October 5, 2007

Re: Addendum to Report of Subsurface Exploration for SR 823 Bridge over Slocum Avenue (TR-248), SCI-823-0229 L & R, SCI-823-0.00 Portsmouth Bypass (PID #77366), dated September 6, 2007

Per our teleconference dated September 24, 2007, this letter presents our response to your comments on the above-referenced report. Your comments are reiterated below in italic and followed by our response.

TRANSVERSE SECTION - ALTERNATIVE 1
 BRIDGE NO. SCI-823-0229 L&R
 S.R. 823 OVER SLOCUM AVENUE (T.R. 248)

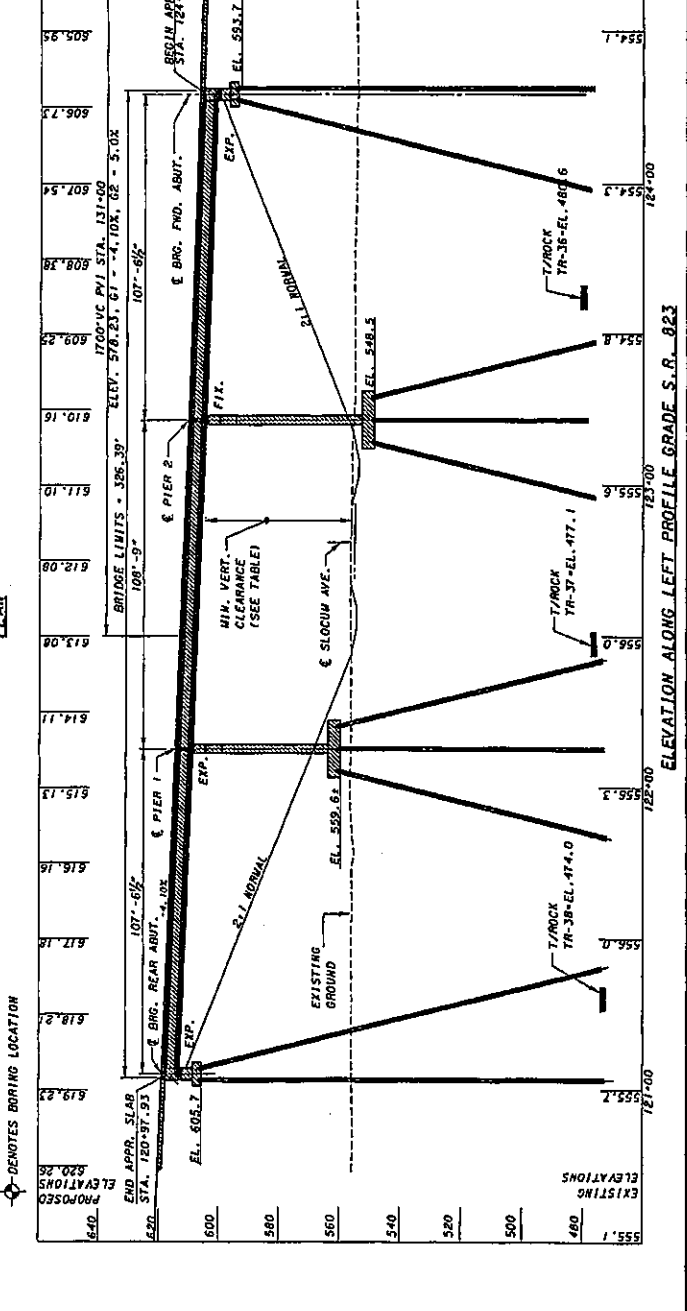
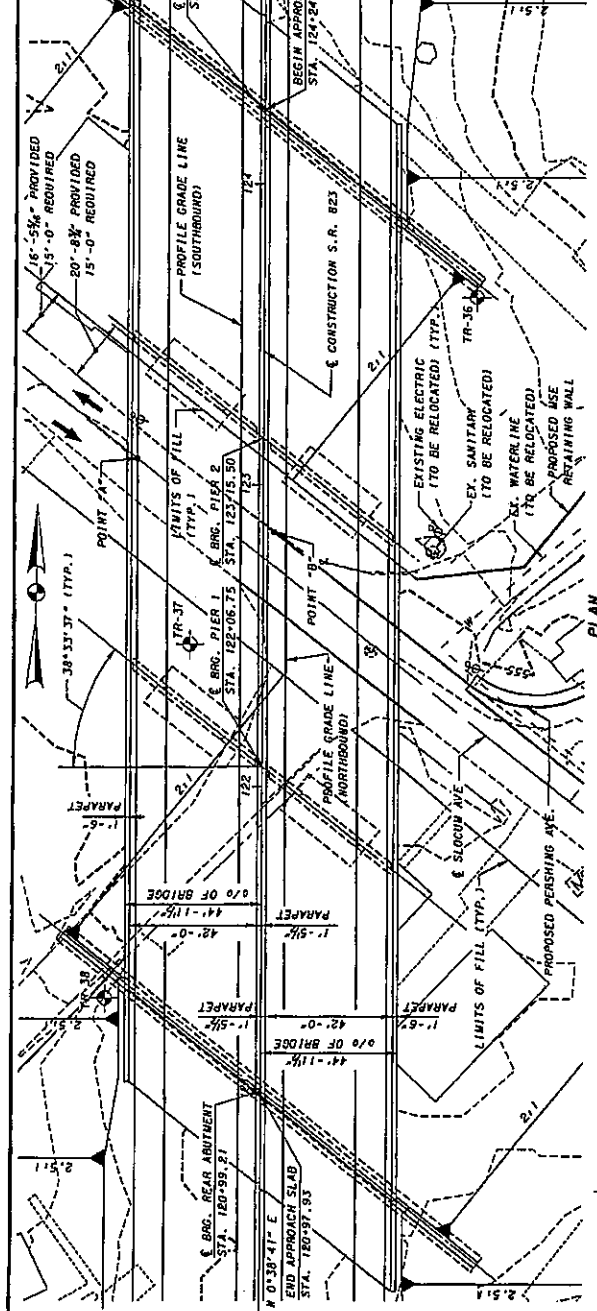
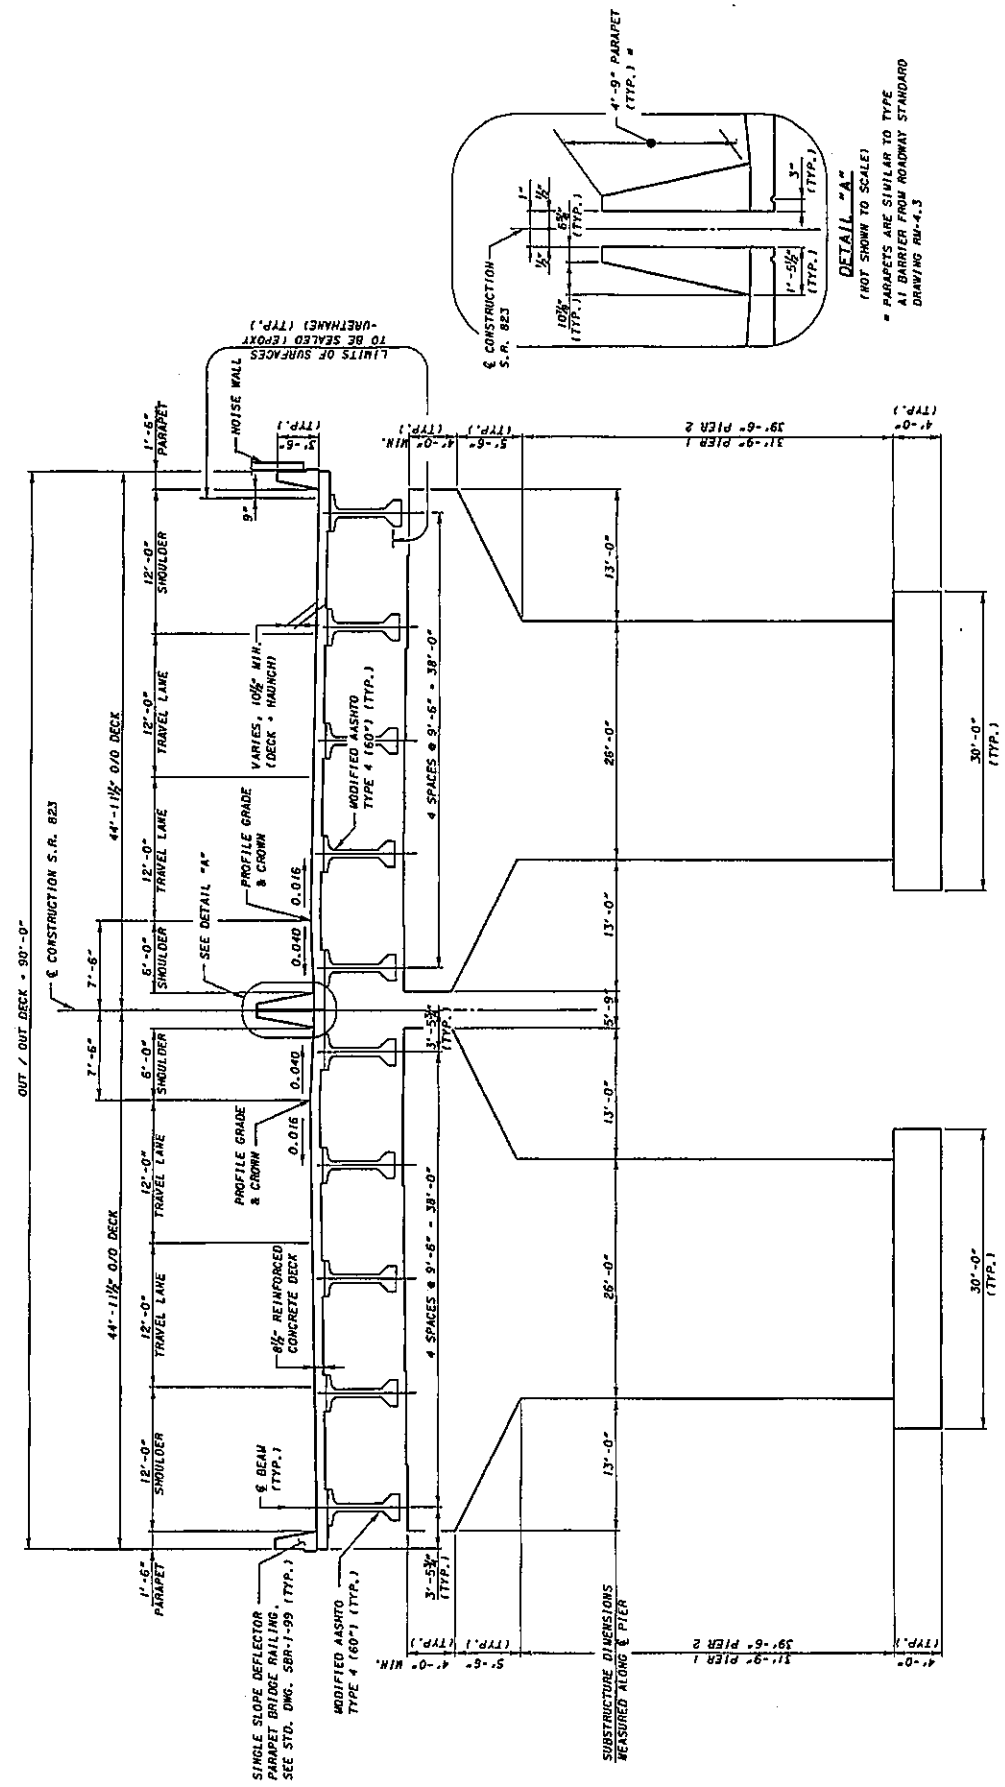
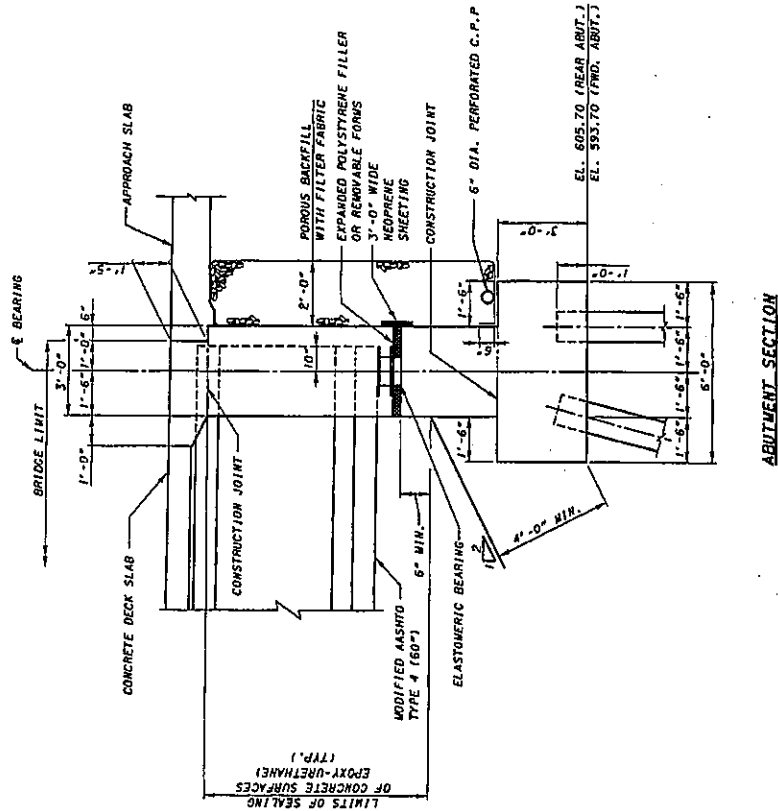
4. *Consider utilizing 3 equal spans due to the fact that the same beam design and strand arrangement will be utilized for all beams and this should result in a more economical design. The 0.7 to 0.8 span ratio, of end span to intermediate span, is a general statement that is intended for steel beams and girders. It appears that there is adequate lateral clearance from Slocum Avenue to accomplish this.*

5. *Verify the bridge length (322.52'). Verify the beam length center to center of bearing. Does the bridge length take into account the distance between the centerlines of bearing at the piers? The span lengths shown in the Profile view on the Site Plan are shown as the centerline of bearing at the abutment to the centerline of the pier cap not the centerline of bearing for the beams.*

8. *When the alignment is finalized include the stationing portion of the bridge number in the Title Block.*

10. *Include a detail (including the reinforcing) of the barriers in the center of the bridge in the Detail plans.*

11. *Include the location (longitude and latitude) of the Structure in the Proposed Structure data block.*

The attached site plan presents three equal spans. Fabricators indicated that detailing the same strand pattern for all of the beams allows them more flexibility within the casting beds. Consideration should be given to specifying the pour sequence in standard drawing PSID-1-99 to minimize cracking that could occur at the pier.

The attached Site Plan more accurately indicates the spans are measured to the centerlines of the substructures.

The attached Site Plans include the bridge number.

The attached Site Plans include the location of the structure.

CLIENT TransSystems Corp / ODOT D-9
 PROJECT SCI-823 Portsmouth Bypass
 SUBJECT over SLOCUM AVE
WSE WALL

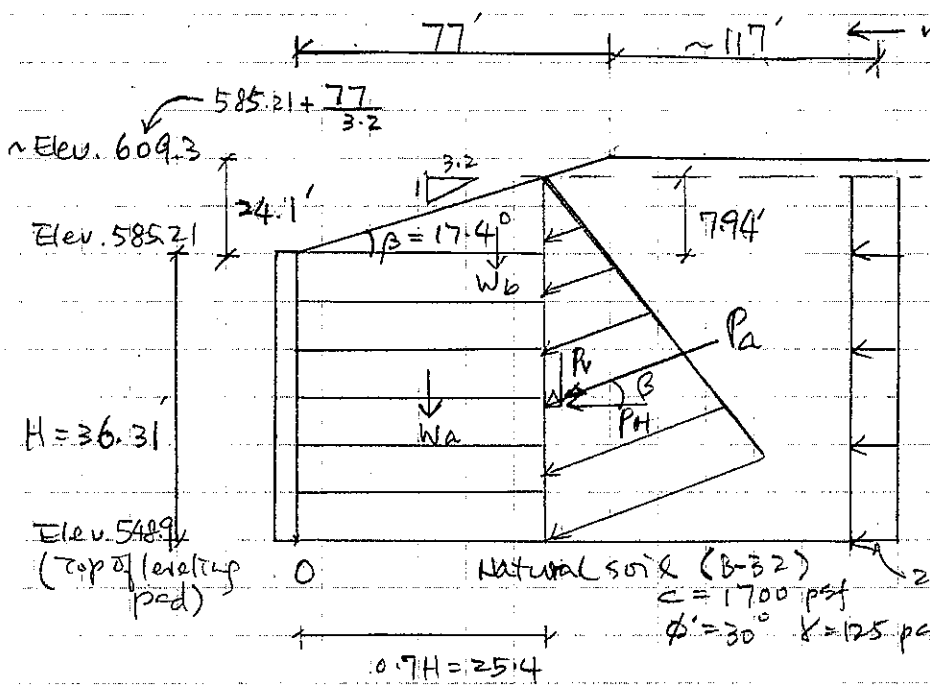
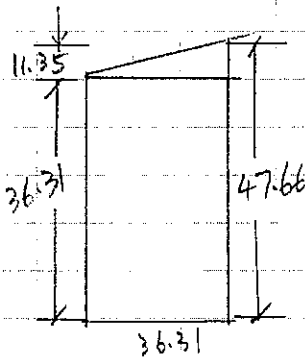
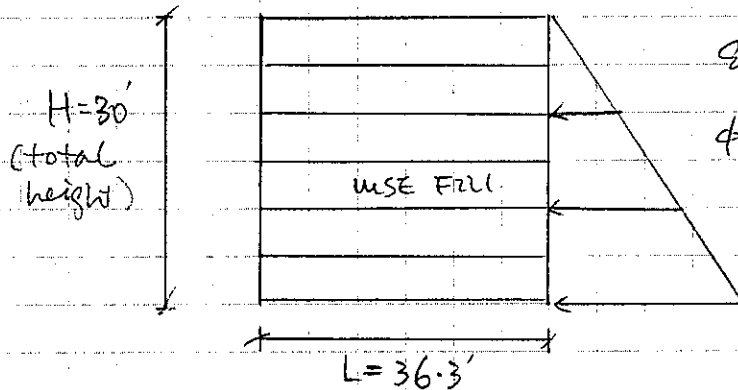
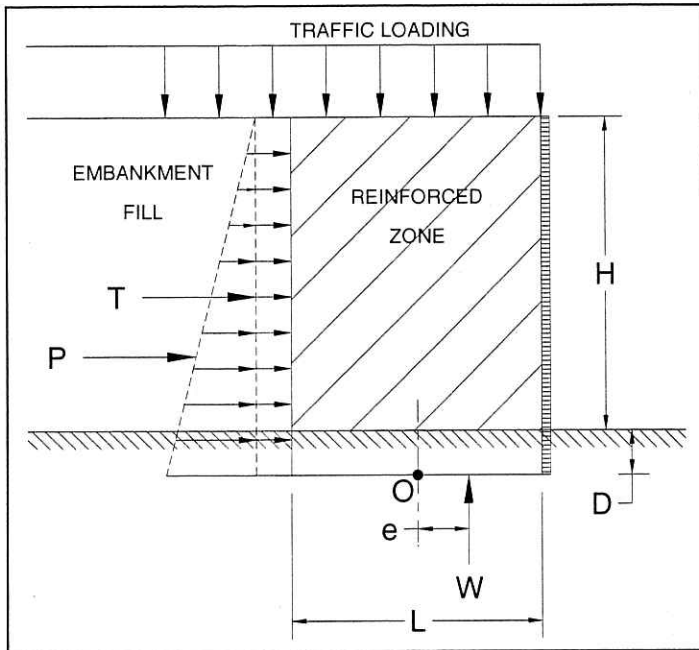
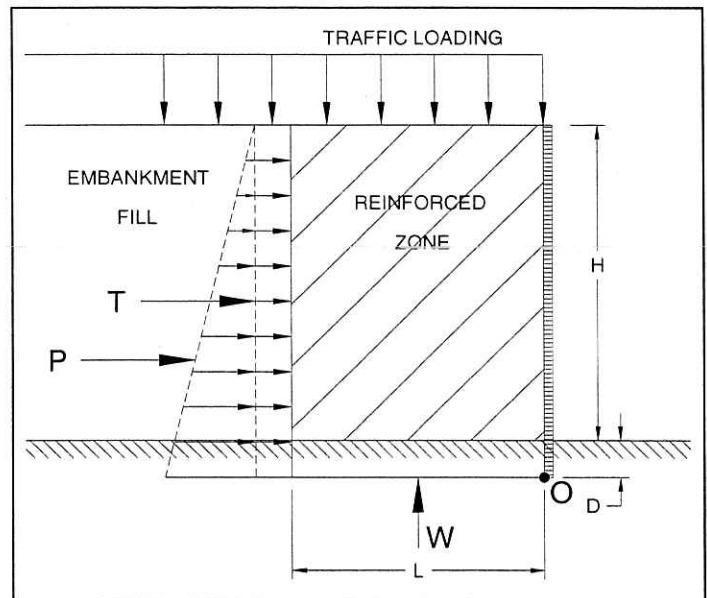
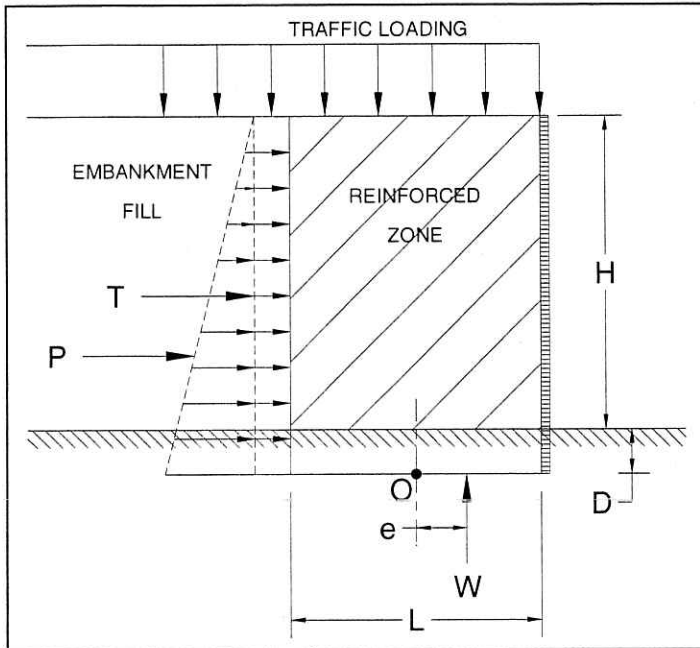
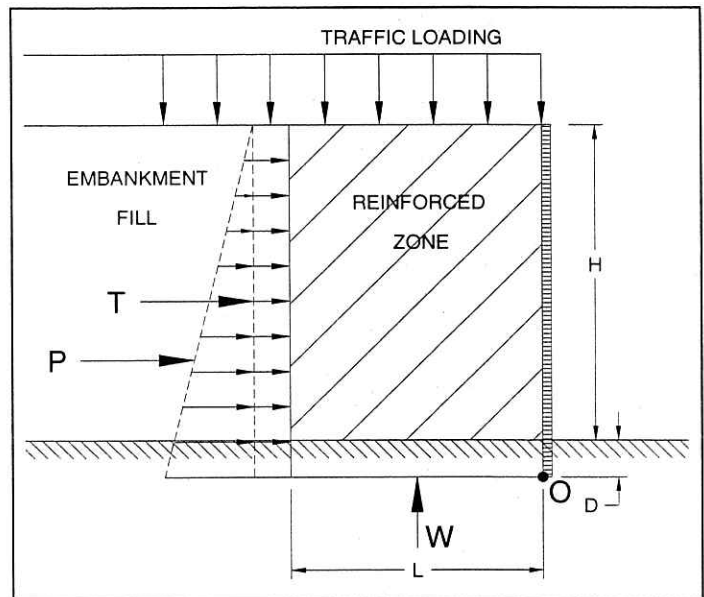
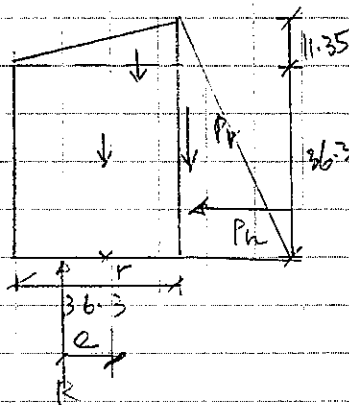
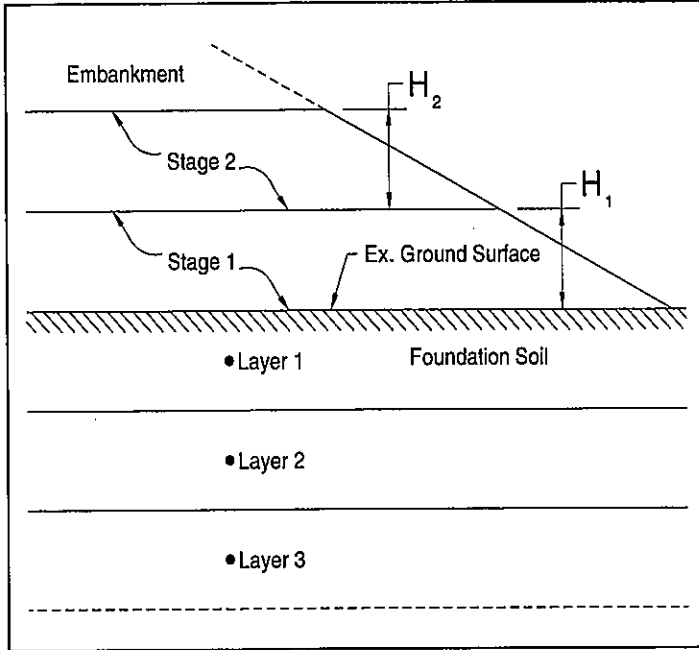
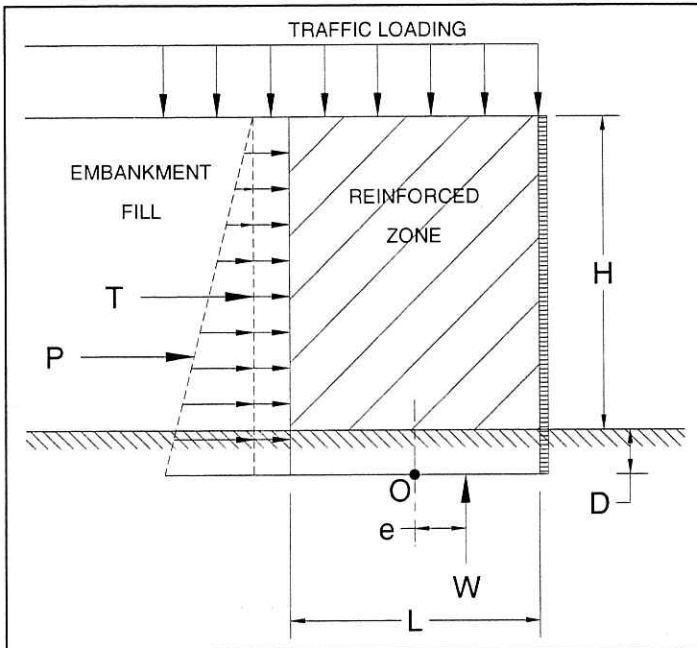
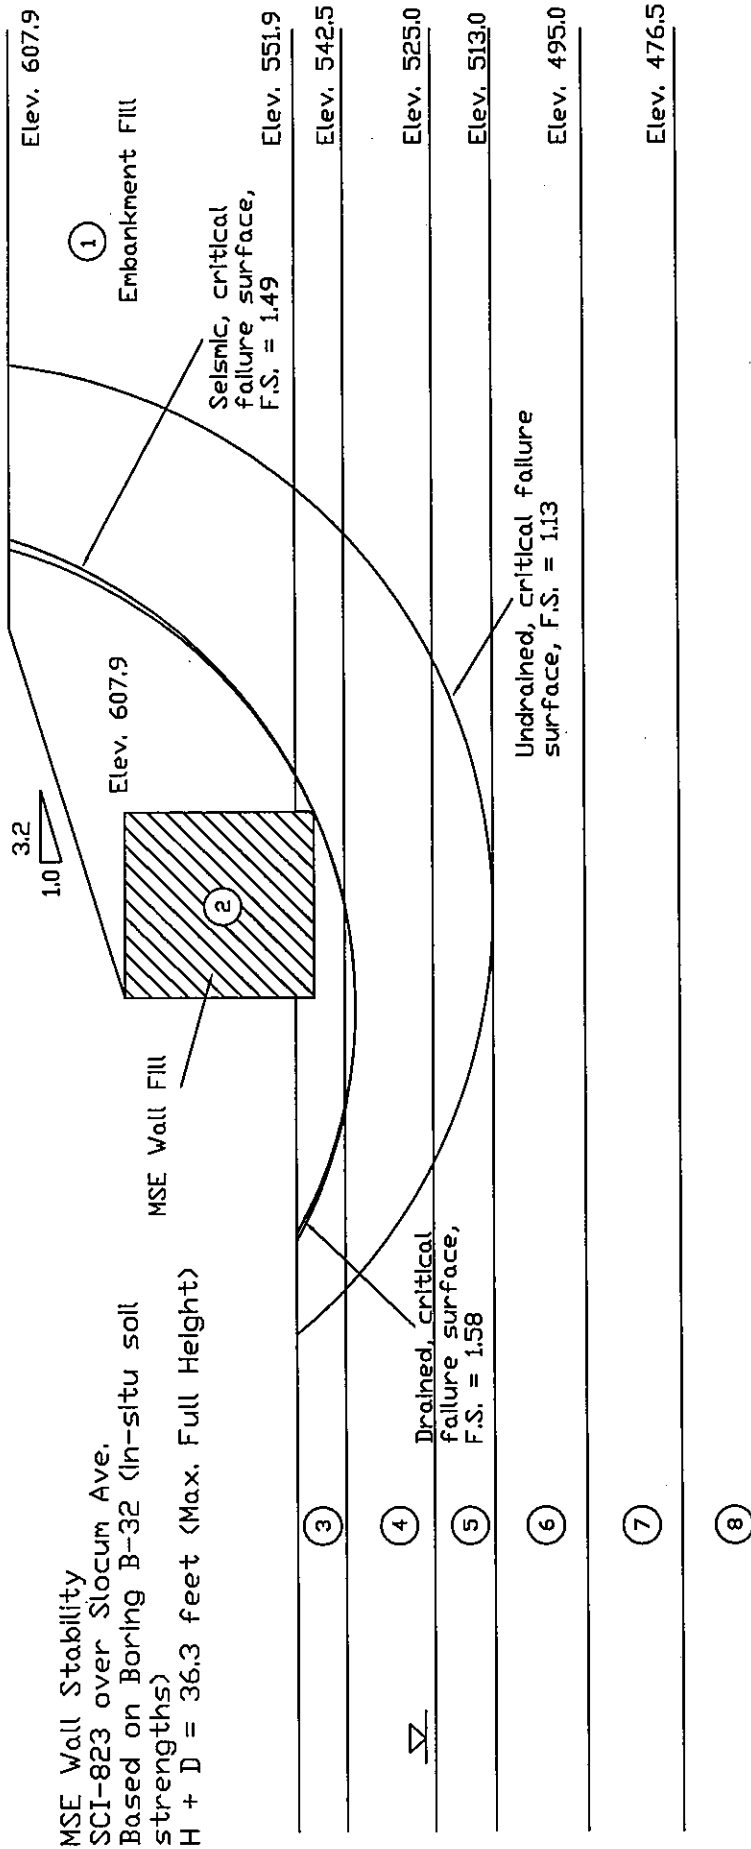
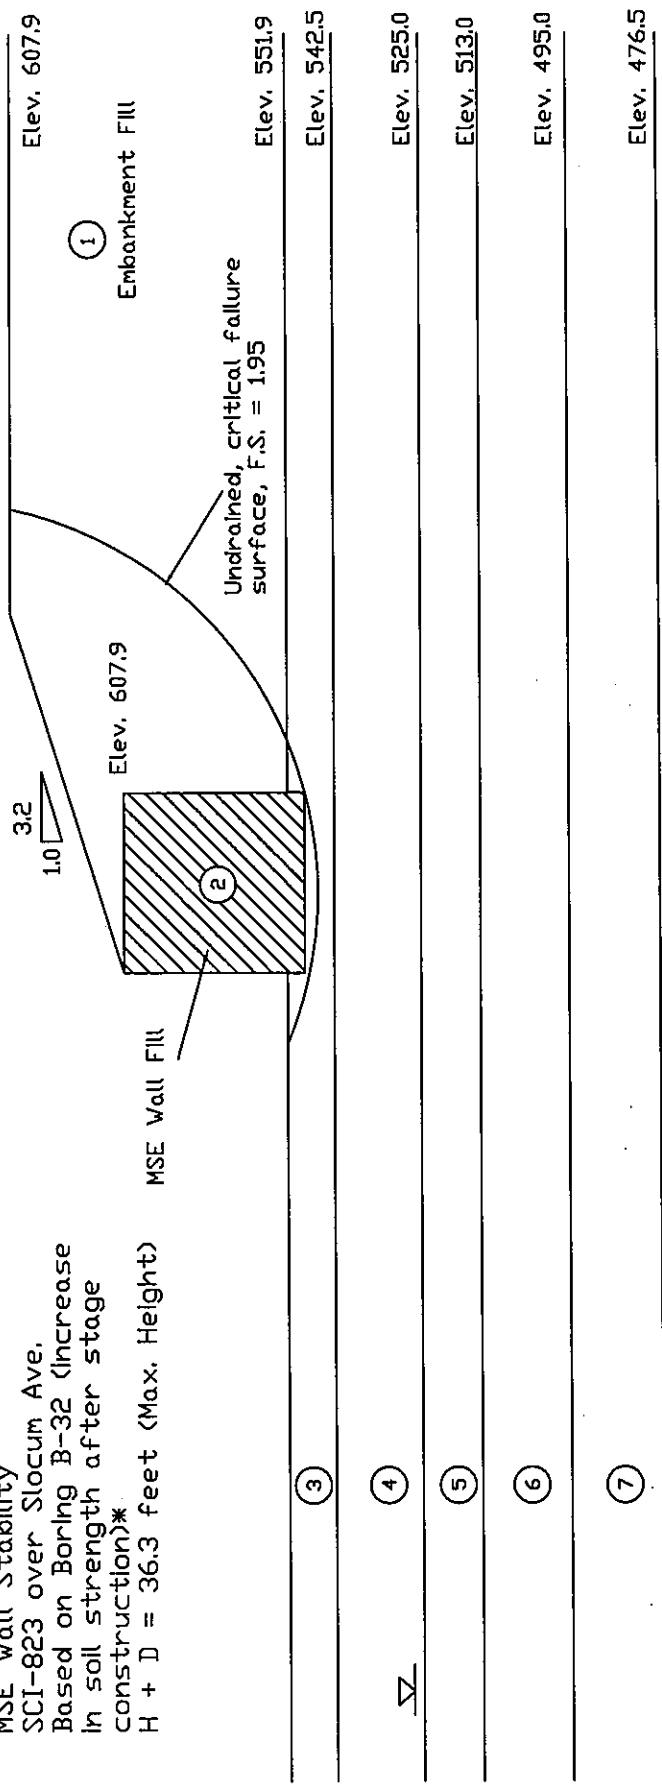
4. *A traffic load of 240 pounds per square foot was used in the MSE wall analyses. However, since the MSE wall would be located from the proposed bridge at a distance more than one-half the maximum wall height, traffic loads should not be considered.*

5. *A 3.2:1 (H:V) backfill slope perpendicular to the highest wall section was used in the analysis. However, according to the preliminary wall design plans, the backfill slope perpendicular to the highest wall section would be level and the 3.2:1 (H:V) backfill slope would be at a wall section approximately 25 feet northeast of the highest wall section. Please clarify your assumptions made in the selection of wall section.*

The stability analyses for the MSE wall were performed without a traffic load. The analyses indicate a slight increase in the factors of safety for overturning,

sliding and bearing capacity. However, these increases do not change any of our original recommendations concerning the MSE wall. A copy of the stability analyses without a traffic load is attached.

It is understood that the backfill slope perpendicular to the highest wall section will be level. However, since the backfill slope will vary along the wall alignment, any backfill slopes that are out of square with the highest wall section would be non-zero slopes. As a result, the highest wall section with a level backfill slope was not used for the analysis. Since the sloping backfill will create different loading conditions than the level backfill, the wall was analyzed using a critical wall section, which consisted of the highest wall height and a 3.2:1 (H:V) backfill slope.
